**SUBJECT:** NuScale Power, LLC Supplemental Response to NRC Request for Additional Information No. 151 (eRAI No. 8974) on the NuScale Design Certification Application

NuScale Supplemental Response to NRC Request for Additional Information eRAI No. 8974

### **NRC Question No.:** 03.08.04-23

**Figure 1 - Enveloping ISRS of cases 1, 2 and 3 at the CNV skirt of NPM1**

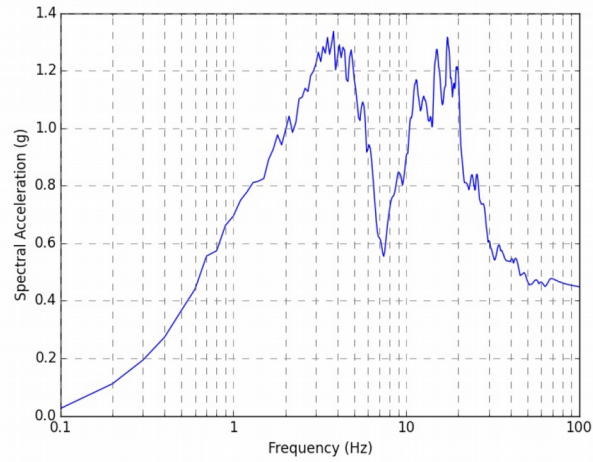
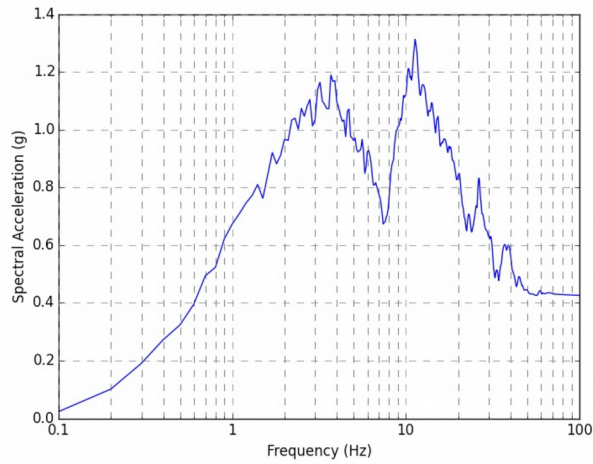
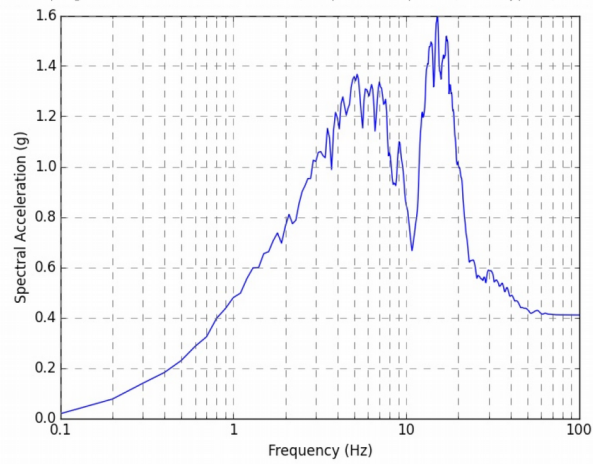
5. The staff requests the applicant to provide an ISRS at the NPM support skirt location that is consistent with the input used for the NPM analysis documented in TR-0916-51502 and identify the node(s) for such ISRS.

At the CNV skirts of NPM1 and NPM6, response spectra are generated for the time histories at the eight spider nodes, corresponding to the eight spider elements. The SASSI node numbers are listed in Table 2 of this response.

The resulting spider node spectra are then averaged for each module. This results in nine averaged skirt response spectra for each module, based on the three seismic cases provided (Soil Type 7, Capitola time history, cracked concrete nominal stiffness, cracked concrete reduced stiffness, uncracked concrete nominal stiffness), each with three components (X, Y, and Z). The ISRS of the nine averaged skirt response spectra is then enveloped for NPM1 and NPM6 in the X, Y, and Z directions. The six resulting enveloping ISRS (two modules x one skirt support x three directions) for the NPM1 and NPM6 CNV skirts are shown in Figures 1 and 2.

Figure 3.7.2-142: Floor ISRS Locations at TOC EL 24'-0"

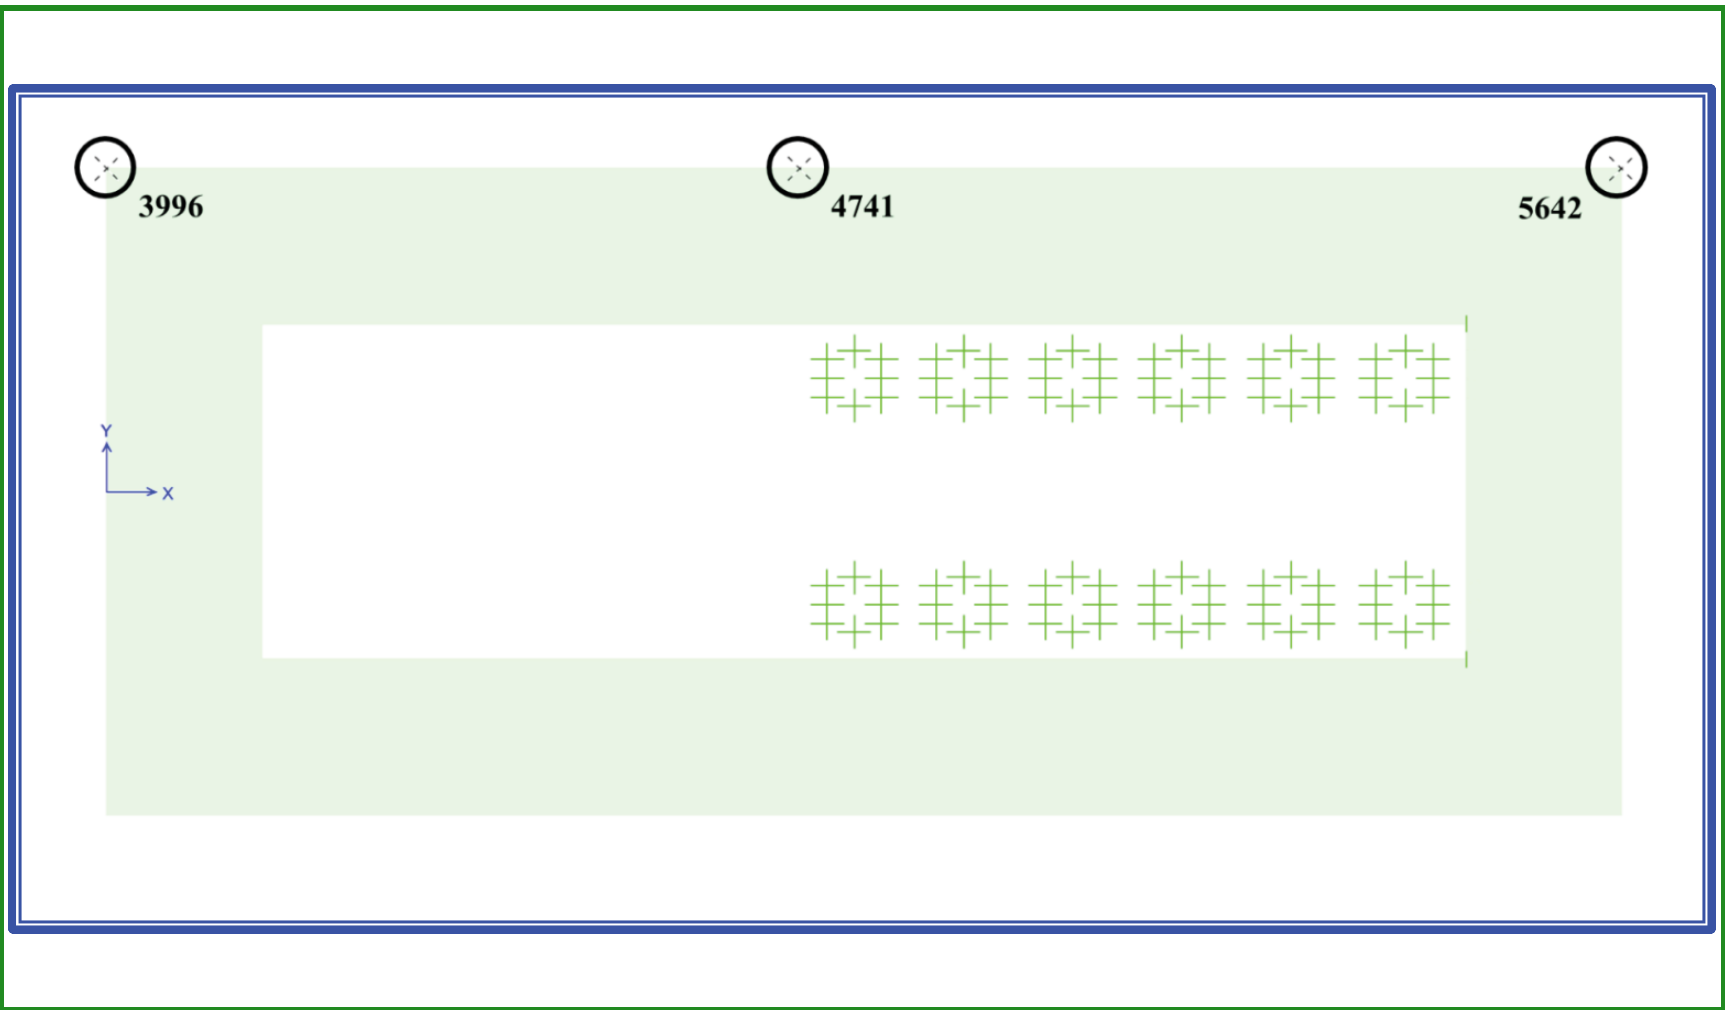
4. Further, the staff requests the applicant to explain how the floor ISRS are developed; whether they account for contributions from all or selected nodes on that floor (if selected, criteria and justification for such selection) and a method of incorporation (averaging or enveloping).

Table 3.7.2-53 is added to the FSAR to list the nodes enveloped at each floor to produce the floor ISRS. Figures 3.7.2-142 through 3.7.2-148 have been added to the FSAR to show the locations of the nodes.
